Brownwood LE- ADA Evaluation

LE- Brownwood TX, ADA Evaluation
301 Main St Suite D
Brownwood, TX 76801
Accessibility Evaluation
Inspection Date: 05/09/2023
Inspectors: Christopher Meza

Report Date: 01/14/2024

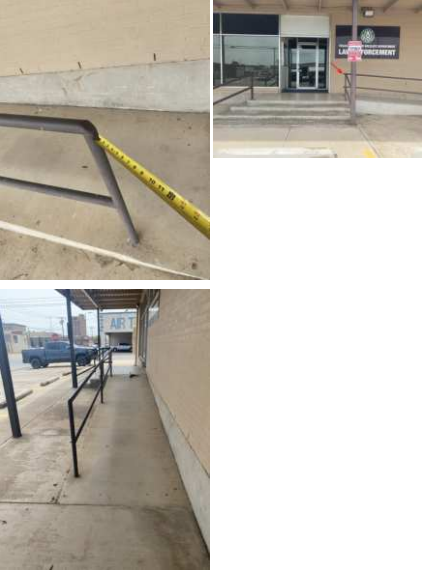
| Finding Number | Area Description | Finding | As Built | Recommendation | Citation | Code Text | Photos |
|----------------|---|--|--|---|---|--|---|
| 2 | Exterior of Property (Public): Parking Lot (1 Space) 1 Van - Van Accessible Stall | The accessible parking stall is not wide enough. Each parking space must be at least 11 feet wide and shall be marked to define the width. The measurements of parking spaces and access aisles shall be made from the centerline of the markings. Alternatively, the stall can be 8 feet wide minimum and the access aisle may be 8 feet wide. The measurements of parking spaces and access aisles shall be made from the centerline of the markings. Where the parking space is not adjacent to another parking space or access aisle, the measurement shall be permitted to include the full width of the line defining the parking space. | Van accessible stall is 9.7' with access aisle of 6.3' Van stall requirements are; van stall 11' with access aisle 5' or van stall 8' with access aisle 8' | https://www.access-board.gov/ada/#ada-502_2 | 2012 TAS Section: 502.2 2010 ADAS Section: 502.2 | <p><u>2012 TAS Section 502.2</u> Car parking spaces shall be 96 inches (2440 mm) wide minimum and van parking spaces shall be 132 inches (3350 mm) wide minimum, shall be marked to define the width, and shall have an adjacent access aisle complying with 502.3.</p> <p><u>2010 ADAS Section 502.2</u> Car parking spaces shall be 96 inches (2440 mm) wide minimum and van parking spaces shall be 132 inches (3350 mm) wide minimum, shall be marked to define the width, and shall have an adjacent access aisle complying with 502.3.</p> |  |

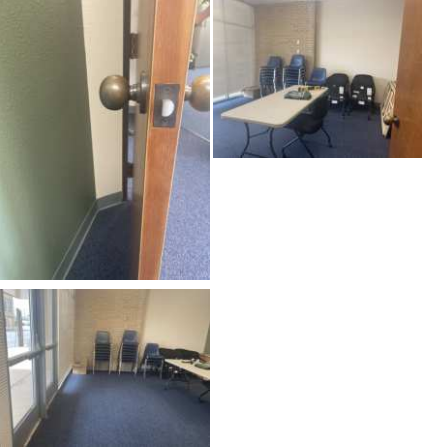
| Finding Number | Area Description | Finding | As Built | Recommendation | Citation | Code Text | Photos |
|----------------|---|---|--|--|---|---|---|
| 9 | Exterior of Property (Public): Path of Travel to Building - Entrance Ramp (Non Curb Ramp) | The ramp run has not been provided with edge protection. The floor or ground surface of the ramp run or landing shall extend 12 inches minimum beyond the inside face of a handrail or a curb or barrier shall be provided that prevents the passage of a 4 inch diameter sphere, where any portion of the sphere is within 4 inches of the finish floor or ground surface. | There is no edge protection provided on (L) side of non curb ramp. 2 ways to satisfy compliance. 1- install bottom bar at 4" or less 2- add ground surface to extend 12" minimum from handrails This only applies to (L) side of ramp. | Edge protection https://www.access-board.gov/ada/#ada-405_9 Extended ground or floor surface https://www.access-board.gov/ada/#ada-405_9_1 Curb or barrier https://www.access-board.gov/ada/#ada-405_9_2 | 2012 TAS Section: 405.9.1, 405.9.2 2010 ADAS Section: 405.9.1, 405.9.2 | <p><u>2012 TAS Section 405.9.1</u> <i>The floor or ground surface of the ramp run or landing shall extend 12 inches (305 mm) minimum beyond the inside face of a handrail complying with 505.</i></p> <p><u>2012 TAS Section 405.9.2</u> <i>A curb or barrier shall be provided that prevents the passage of a 4 inch (100 mm) diameter sphere, where any portion of the sphere is within 4 inches (100 mm) of the finish floor or ground surface.</i></p> <p><u>2010 ADAS Section 405.9.1</u> <i>The floor or ground surface of the ramp run or landing shall extend 12 inches (305 mm) minimum beyond the inside face of a handrail complying with 505.</i></p> <p><u>2010 ADAS Section 405.9.2</u> <i>A curb or barrier shall be provided that prevents the passage of a 4 inch (100 mm) diameter sphere, where any portion of the sphere is within 4 inches (100 mm) of the finish floor or ground surface.</i></p> |  |

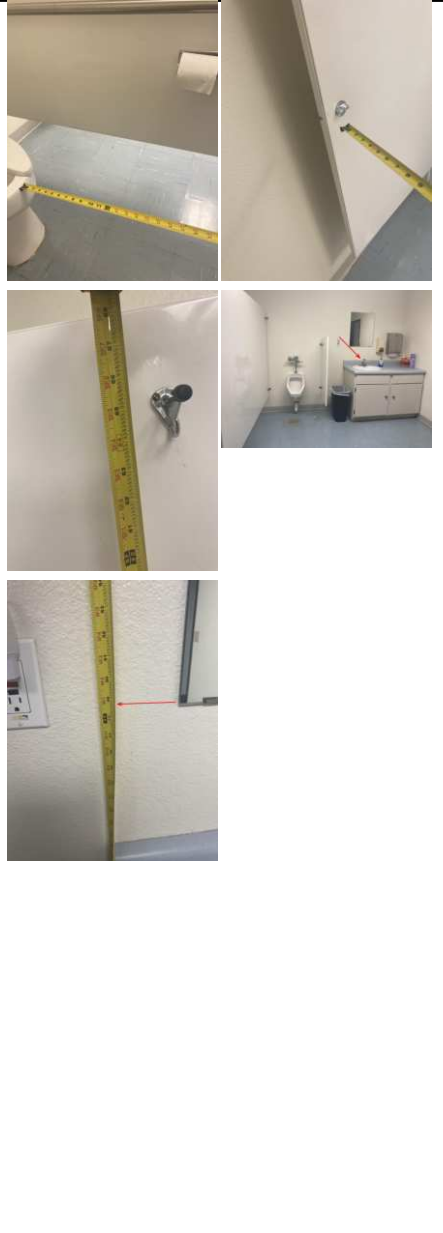
| Finding Number | Area Description | Finding | As Built | Recommendation | Citation | Code Text | Photos |
|----------------|---|---|--|---|---|---|---|
| 10 | First Floor Main Building LOBBY (Public): Entrance into Lobby - Entrance Door | The tactile EXIT sign is missing at the door. Wall signs identifying exits shall have characters raised 1/32 inch minimum and shall be uppercase characters a minimum of 5/8 inch and a maximum of 2 inches high. Braille shall be placed directly below the tactile characters; flush left or centered. Signs shall be located a minimum of 48 inches above the floor, measured from the baseline of the lowest tactile characters and 60 inches maximum above the finish floor or ground surface, measured from the baseline of the highest tactile characters. Where a tactile sign is provided at a door, the sign shall be located on the latch side. Where a tactile sign is provided at double doors the sign shall be located to the right of the right-hand door. Where there is no wall space at the latch side of a single door or at the right side of double doors, signs shall be located on the nearest adjacent wall. | Where visual EXIT is provided, accompanying tactile EXIT sign must also be provided for same doorway. Doorway exit signs and emergency exits with emergency exit signs that are overhead or visual only, or pictograms only, must have an accompanying ADA Braille sign. Exit passages, including doors, stairs and routes, must be identified with tactile ADA signage. Signs must include braille and raised characters. Pictograms are optional. Main exterior exit doors or gates that are obviously and clearly identifiable as exits need not have exit signs where approved by the building official. | https://www.access-board.gov/ada/#ada-216_4_1 | 2012 TAS Section: 216.4.1 2010 ADAS Section: 216.4.1 | <u>2012 TAS Section 216.4.1</u> <i>Doors at exit passageways, exit discharge, and exit stairways shall be identified by tactile signs complying with 703.1, 703.2, and 703.5.</i> <u>2010 ADAS Section 216.4.1</u> <i>Doors at exit passageways, exit discharge, and exit stairways shall be identified by tactile signs complying with 703.1, 703.2, and 703.5.</i> |  |
